Applicable Urban Design Priorities Project Should Achieve

The phase I project site is located in the northeast corner of the overall Canyon in Oak Cliff master plan area. The overall master plan area is bound by Interstate 30, Westmoreland, Ft Worth Avenue and Pinnacle Park Boulevard. The vision for full build out of the master plan area proposes a blend of mixed-use, multi-family, office and retail space.

The phase I retail development submitted for urban design peer review is located at the northeastern corner of the overall project site and proposes both hotel and retail uses.

The Canyon - Retail Phase I

CONCEPTUAL LANDSCAPE PLAN

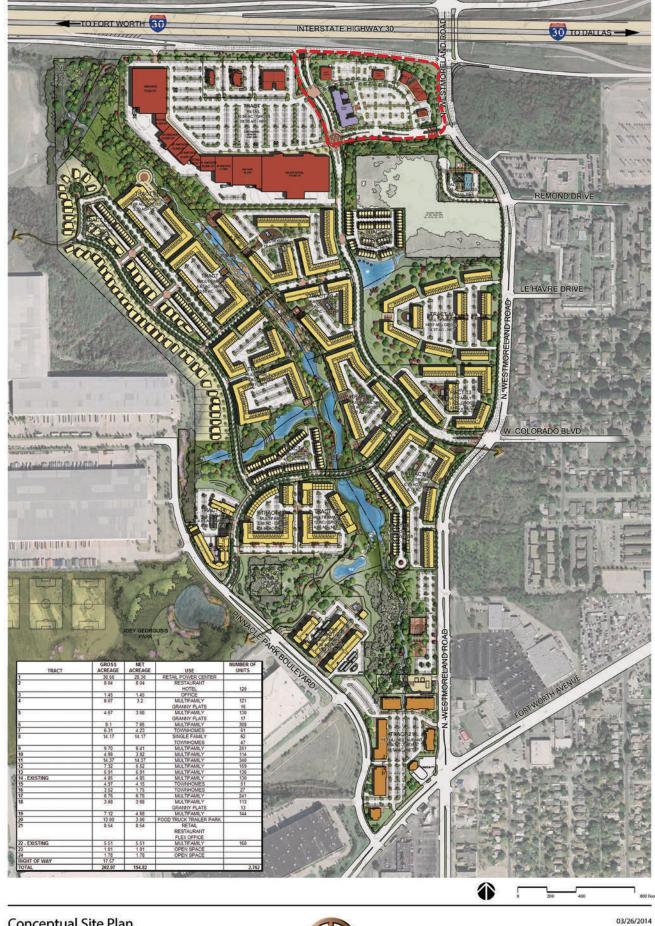
[1] Public realm design should link individual buildings through a unified organization of sidewalks and hardscape/public spaces that introduce places that can both be occupied and lingered in -

Careful consideration should be given to the relationship of the proposed buildings with a unifying public realm and landscape scheme that promotes walkability and creates public spaces to both occupy and linger in.

[2] Low impact development techniques should by utilized as a primary landscape strategy throughout the site -

Integrated storm water management and low impact development practices should be a primary focus of the overall landscape strategy and organization of the site.
